LOCATION: Royal Oaks Drive, east of Kleberg Road

REQUEST: An application to create one 0.475-acre (20,688.30 square foot) lot from a tract of land in City Block A/8812 on property located on Royal Oaks Drive, east of Kleberg Road.

PRELIMINARY PLAT

CITY PLAN FILE NO. S234-141

|  1:2,400 | <p>EXISTING AREA ANALYSIS MAP</p> <p><input type="checkbox"/> Area of Request</p> <p><input type="checkbox"/> Recent History</p> | Case no: <u>S234-141</u> Date: <u>7/9/2024</u> |

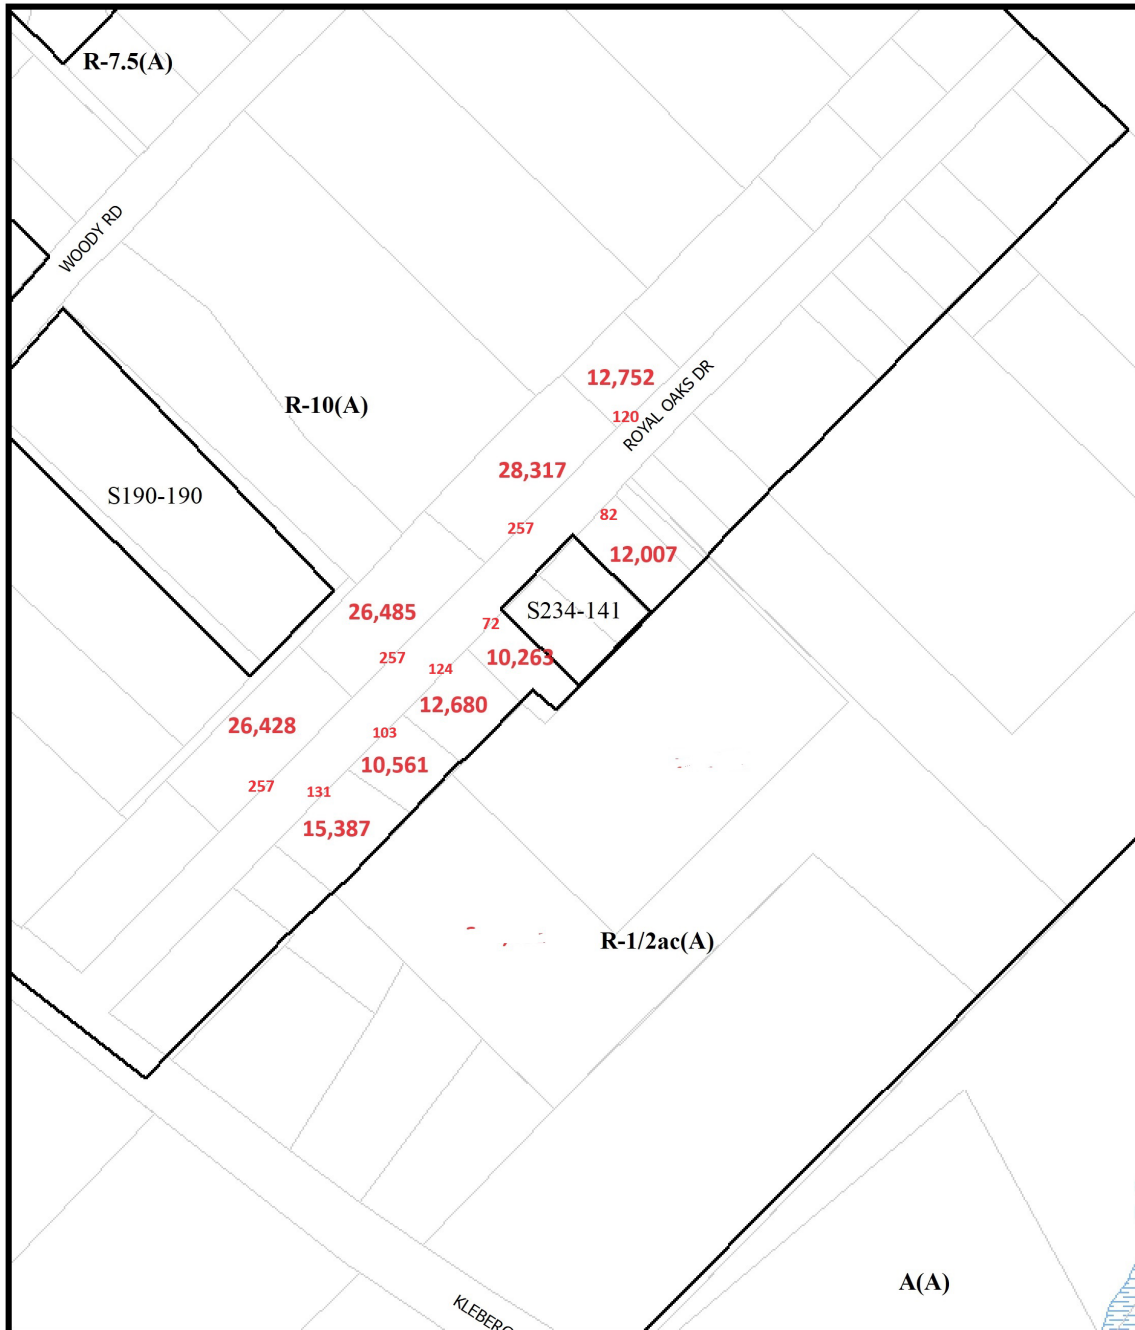
- The properties on the north line of Royal Oaks Drive have lot area ranging in size from 12,752 square feet to 28,317 square feet and lot widths ranging in size from 120 feet to 257 feet and are zoned R-10(A) Single Family District. (*Please refer to the existing area analysis*).
- The properties on the south line of Royal Oaks Drive have lot area ranging in size from 10,263 square feet to 15,387 square feet and lot widths ranging in size from 72 feet to 131 feet and are zoned R-10(A) Single Family District. (*Please refer to the existing area analysis*).

Staff finds that there is a variation in lot pattern within the immediate vicinity of the request (*Refer to the existing area analysis map and aerial map*). The request complies with the zoning requirement of the R-10(A) Single Family District and is in compliance
